Title - Sujet SAR Station Building Construction	
Solicitation No. - N° de l'invitation F1700-165107/A	Amendment No. - N° modif. 004
Client Reference No. - N° de référence du client F1700-165107	Date 2016-11-25
GETS Reference No. - N° de référence de SEAG PW-\$PWY-019-7908	
File No. - N° de dossier PWY-6-39208 (019)	CCC No./N° CCC - FMS No./N° VME
Solicitation Closes - L'invitation prend fin at - à 02:00 PM on - le 2016-12-02	
Time Zone Fuseau horaire Pacific Standard Time PST	
F.O.B. - F.A.B. Plant-Usine: <input type="checkbox"/> Destination: <input checked="" type="checkbox"/> Other-Autre: <input type="checkbox"/>	
Address Enquiries to: - Adresser toutes questions à: Ngan, Ken (PWY)	Buyer Id - Id de l'acheteur pwy019
Telephone No. - N° de téléphone (604) 658-2755 ()	FAX No. - N° de FAX (604) 775-6633
Destination - of Goods, Services, and Construction: Destination - des biens, services et construction: DFO - SAR Station - Campbell River, BC

This Solicitation Amendment 004 is raised to incorporate Addendum #2.

***The following changes in the Tender Documents are effective IMMEDIATELY.
This addendum will form part of the Contract Documents***

7a GEAR STORAGE SHELVES

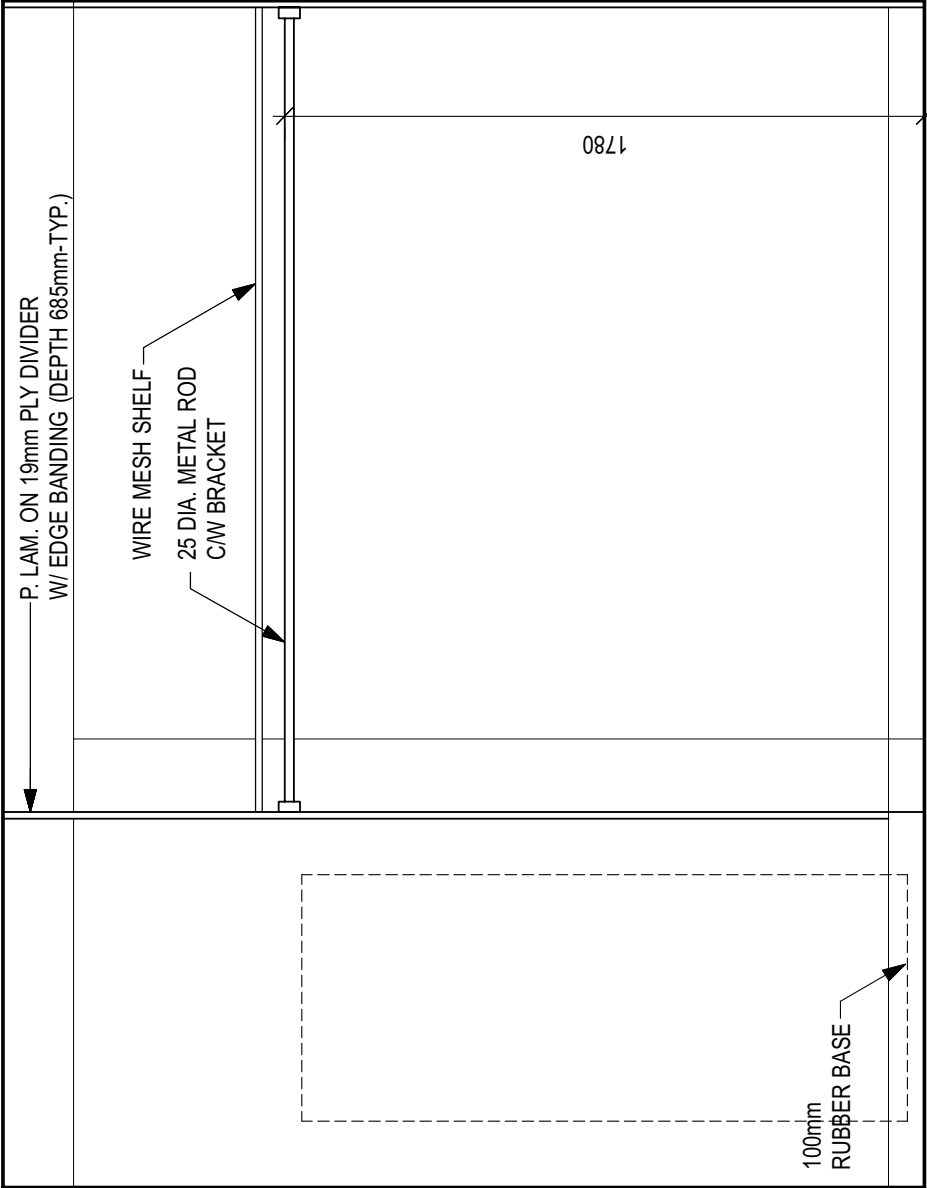
A 7.02 detail 7a & 7b

See attached revised elevations indicating the two rod and shelving conditions occurring in the room 112 gear storage. Secure Storage room 113 rod and shelf to match detail 7b.
